October 7, 2011

**Re: Task Order: PEER REVIEW OF CH2MHILL'S FEBRUARY 2007 *GROUNDWATER BACKGROUND STUDY REPORT, HINKLEY COMPRESSOR STATION, HINKLEY, CALIFORNIA* PREPARED FOR PACIFIC GAS AND ELECTRIC COMPANY (PG&E)**

Review Subject: *Groundwater Background Study Report, Hinkley Compressor Station, Hinkley, California (BSP3) CH2MHILL, February 2007.*

**Figure 1 Map of Cr(T) and Cr(VI) Sampling Results; Background Study**

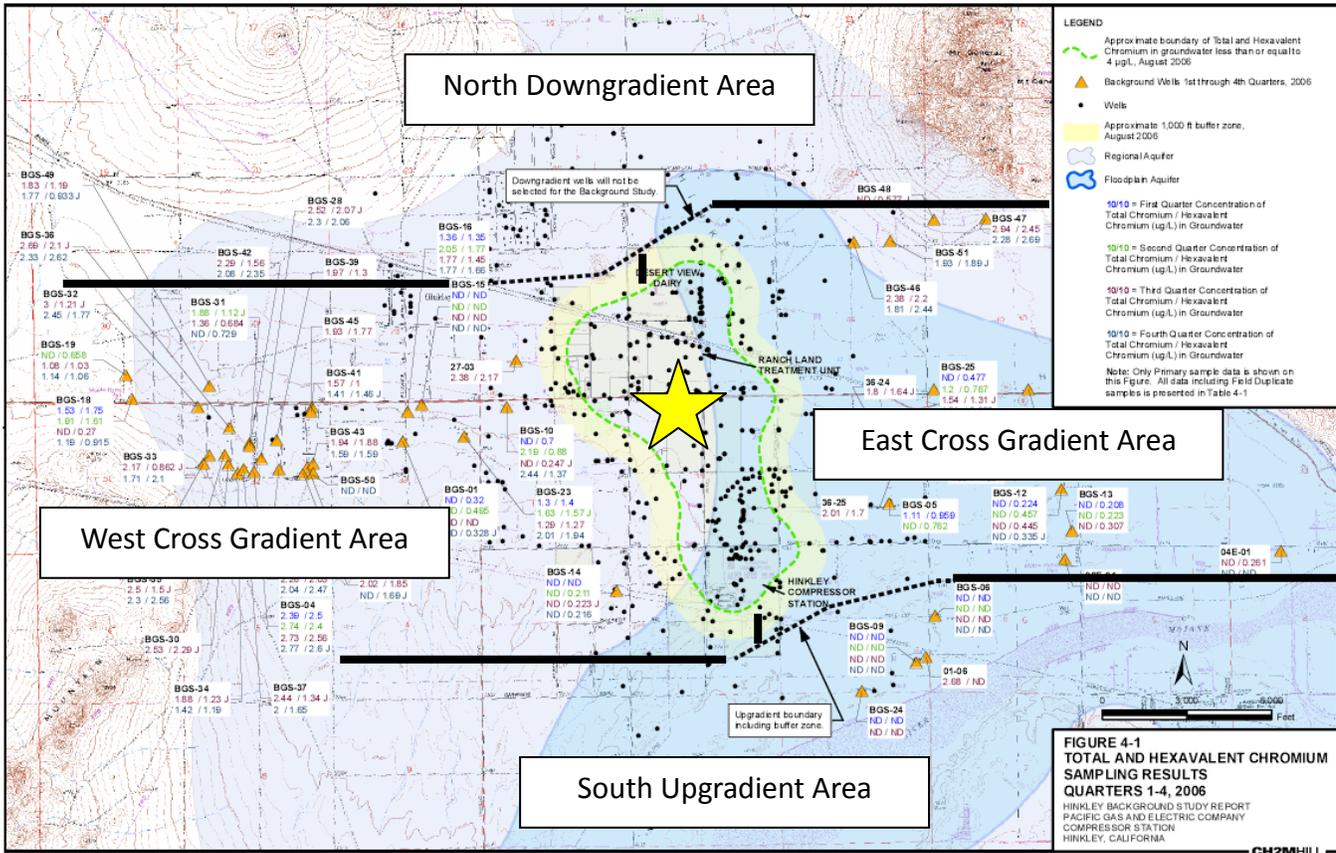
Comments: The wells used for the background study reported in the CH2MHILL (2007) report show an inconsistent pattern of well sampling as shown above. The Hinkley Valley in the background study area can be divided into five main areas (see attached **Figure 1**; based on the Figure 4-1; CH2MHILL 2007 Study). The five main areas are as follows: Core Area, South Upgradient Area, East Cross Gradient Area, West Cross Gradient, and North Downgradient Area. Across these there is an Upper and a Lower Aquifer. These aquifers are separated in most areas by a confining clay aquitard, called the Blue Clay, except as noted below.

Of the areas shown in **Figure 1**, the South Upgradient Area is the most likely to provide natural or background levels of Cr(T) and Cr(VI). Samples from the Mojave River, although more than one mile from the PG&E facilities, may show less anthropogenic influences for background samples of Cr(T) and Cr(VI) for the region.

In addition to the issues listed above regarding the wells being screened in more than one aquifer, the chosen set of 'background' wells are not located adequately upgradient and outside the range of influence of actively pumping (historically or currently) extraction wells (which could be drawing the Cr(VI) plume in an upgradient direction) to be representative of background conditions. Virtually all of the chosen wells are located in a cross gradient position from the main plume with poorly defined cross gradient Cr(T) and Cr(VI) plume boundaries. As noted, well data should reflect specific aquifer zones, not mixed zones. Given the eight decades of intense agricultural pumping, it is possible that with preferred flow pathways (high permeability zones due to lithologic characteristics or geologic faults (Lockhart) or other potential conduits), some of the Cr(T) and Cr(VI) from the Core Area may have migrated over the past decades toward the east or west into the East Cross Gradient Area or the West Cross Gradient Area, respectively (see **Figure 1**).
